RECEIPT DATE: 5-12-16 **ONSITE SEWAGE DISPOSAL SYSTEM** P 558713-1

PROPERTY ADDRESS: 7311 Browns Bridge Road

**From:** Williams, Jeffrey [<mailto:jewilliams@howardcountymd.gov>]  
**Sent:** Friday, February 26, 2016 8:46 AM  
**To:** Aldo Vitucci; John Hoolachan  
**Cc:** Freemon, Robert  
**Subject:** VanNoy PPB BAT plan

**BAT PLAN**  
**VANNOY PROPERTY**  
 PRESERVATION PARCEL 'B', NON-BUILDABLE PRESERVATION PARCEL 'A' & BUILDABLE PRESERVATION PARCEL 'B'

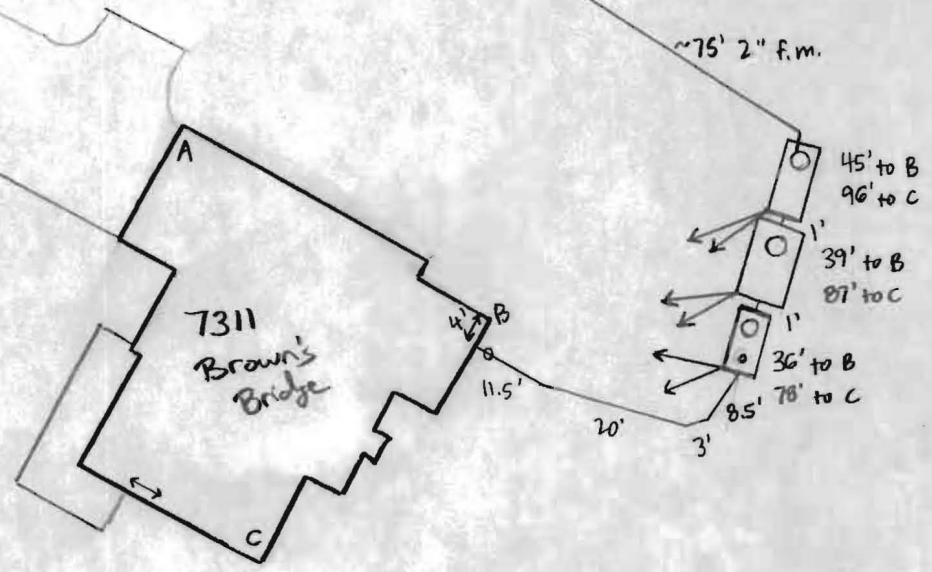
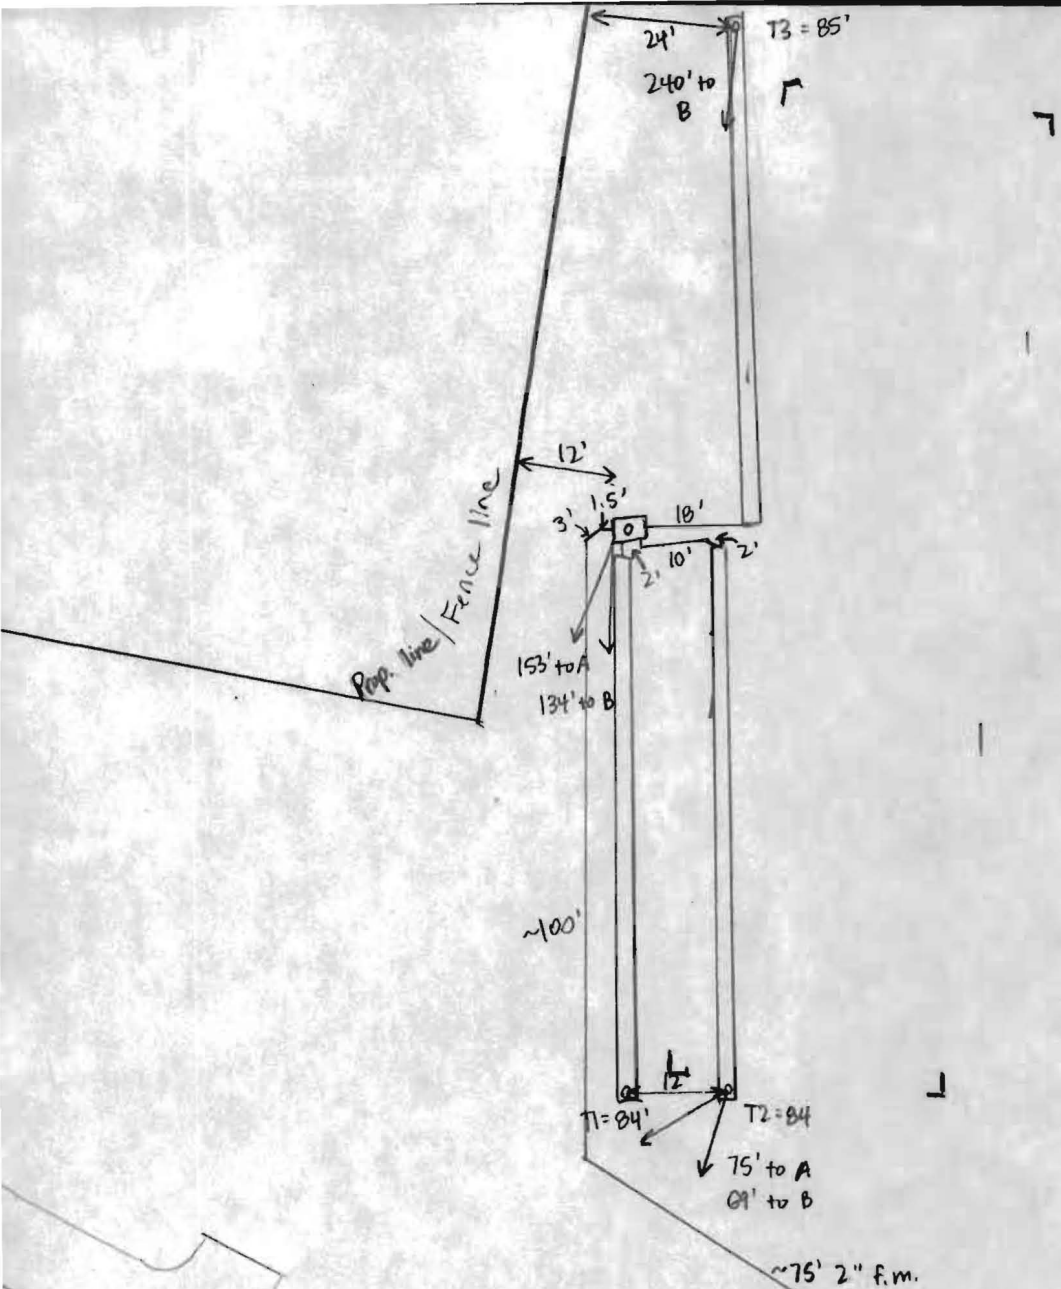
NOTES: \* Area w/ high water table in vicinity of approved SRA. Initial system to be placed outside approved SRA closer to NW boundary line.

7/11/16 Missing Well Check. Upper corner SRA stake missing. Pulled measurements, etc. to correct stake location. Perc results for holes 501 and 505 inconsistent. Trench spec adjusted to fit 1050 gpd design. possible repair area upper part of lot in front of house. Area subject to high water tables. Hoot 1000 BAR to be installed.

7/12/16 T2 + T3 complete + left open 2.5-3' to stone. S. Carroll digging T1 during site visit, using laser to check both bottom + stone depth. 7' bottom. 7/13/16 House connection made. Trash tank and Hoot set, pump tank set during site visit. Ground water at bottom of Hoot tank hole, 9' deep. Mottling at 3.5' in same hole. 7/14/16 D-box installed. 2" force main connected from pump tank. Need Hoot startup certification. 10/5/16 Hoot startup with Mike Sample. Pump pumps effluent to D-box. Alarm sounds. 10/7/16 BAT startup certification received.

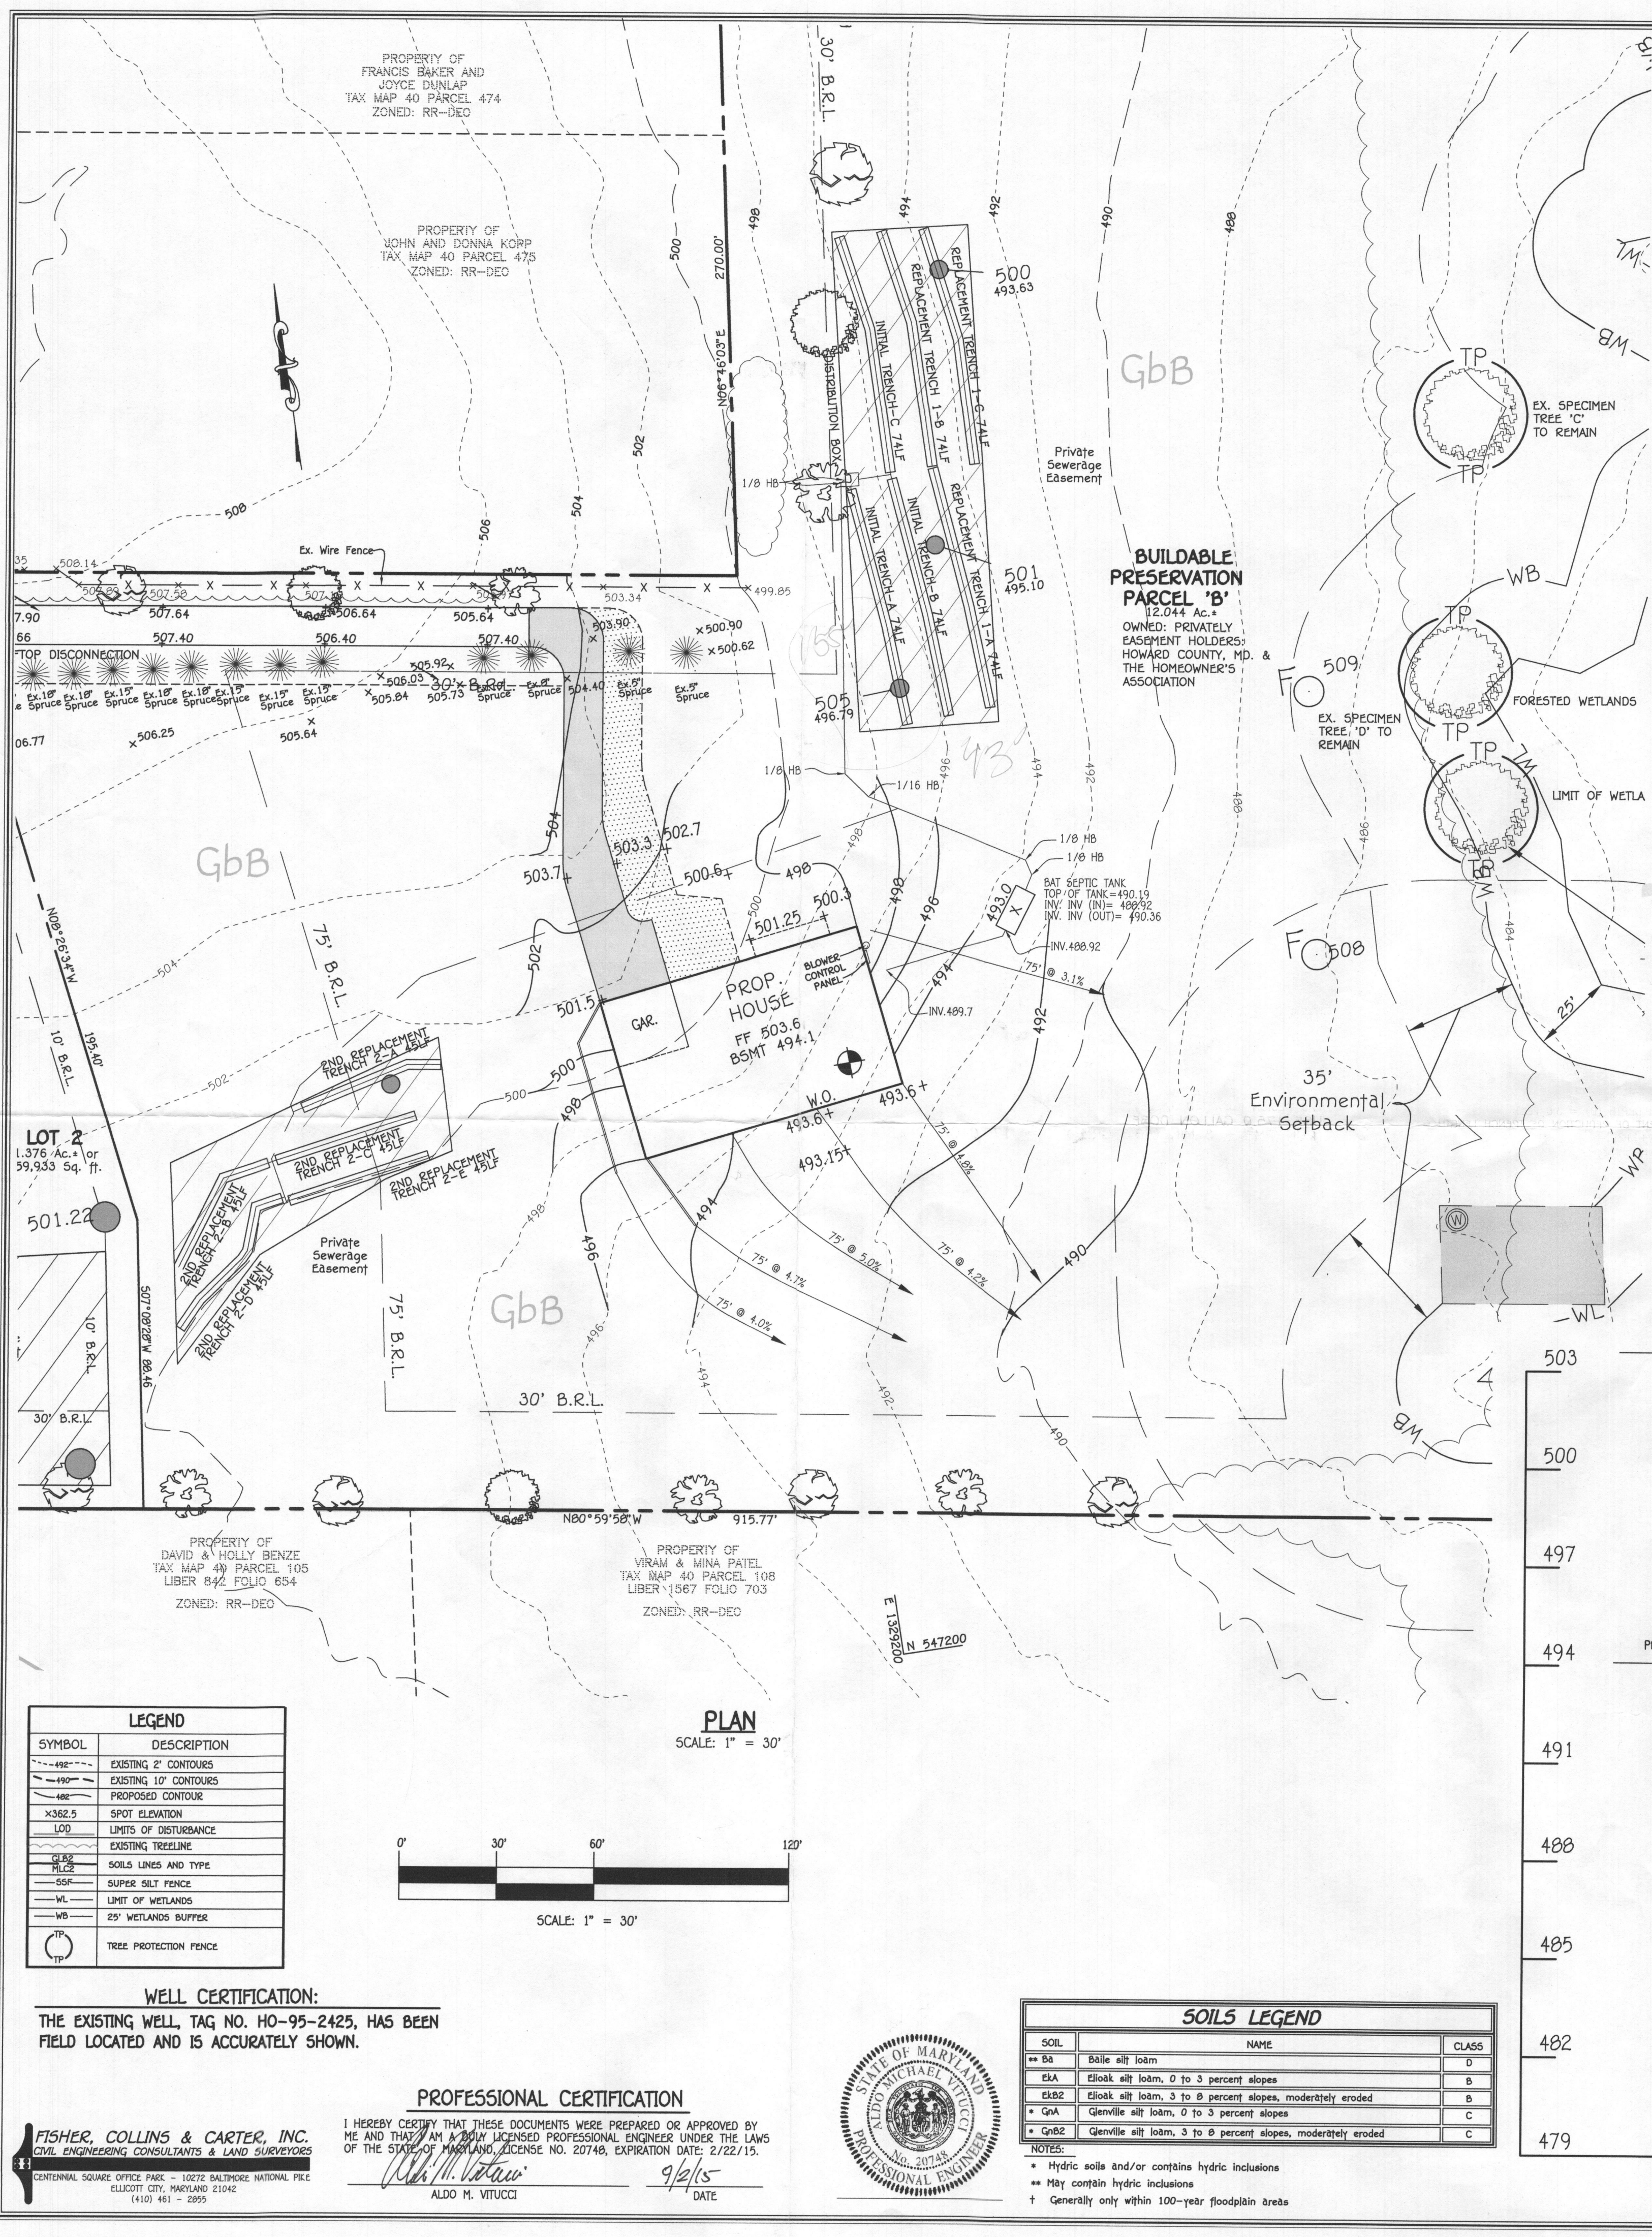
I reviewed the revised BAT plan for Van Noy Pres Parcel B and have one item for correction. The original dose to the d-box was a little high to begin with, but with a 7 bedroom house I let it go. With a smaller design, the dose to the d-box should be smaller. We don't need the dose to be 1/6 design flow when going to gravity trenches. The ideal condition there is to get a smaller dose so as to not overwhelm the box and to allow for more frequent doses. With the Hoot unit, you want to balance that with their ideal timing of 2 minutes per dose. I see on the pump curve that you can easily scale down to the EP04 pump, which would dose at 40 gpm and have a 2 minute dose set to dose 80 gallons per event, which is pretty good.

If you like, I could redline the plan to change the pump and dose or you could choose to resubmit a new plan. Let me know. Thanks

I would appreciate it, if you could change the plan.

**1/6" DESIGN FLOW (1050/6=175)  
USE 175.0 GALLON DOSE  
(RUN TIME = 3 MIN (58.3 GPM x 3 = 175.0 GALLON DOSE)**

**PUMP NEEDS TO HANDLE 58.3 GPM AT 13.2 FT OF HEAD  
USE 0.5 HP (EP05 PUMP)**
